Remarks

Drawings: Replacement/Annotated Sheets

Annotated Sheet

Fig. 2.

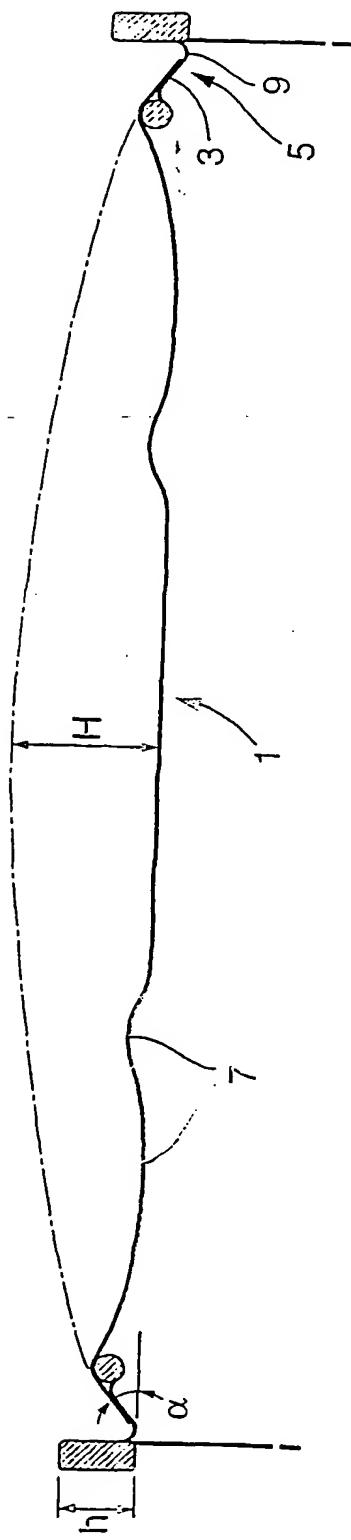
After reconsidering the application prior to receipt of the first Office Action, the principals noted an obvious error in Figure 2 which is described at paragraph **[0022]** as follows:

[0022] In figure 2, it can be seen that the seal surface is inclined at angle α (alpha) which is greater than the foil tangent angle β (beta). This eliminates the peel component and maximises bond failure pressure.

In original Figure 2 the angle α (alpha) is obviously less than the angle β (beta). In the Replacement Sheet the angles of Figure 2 have been changed to correspond to the description at paragraph **[0022]** and new Figure 2 correctly reflects angle α (alpha) being greater than angle β (beta).

The changes in Figure 2 do not involve new matter and simply correspond the angles in Figure 2 to the description in paragraph **[0022]**.
